**Appendix 2: Additional comments from Auckland Transport that are not part of the information request.**

**4. Advisory comments on ITA**

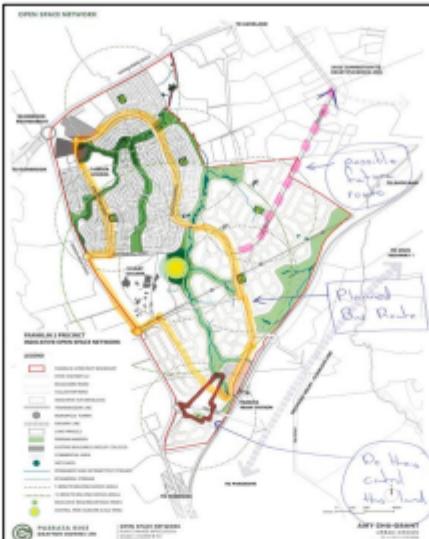
6	Future Bus Route	Figure 1 below shows AT's proposed bus route connecting Paerata Rise to the future train station. It is noted that if Sims Road undergoes further urbanisation beyond the current precinct boundary, an additional bus route may be required (shown in dashed pink on Figure 1 below) and should be considered when designing the indicative road network.
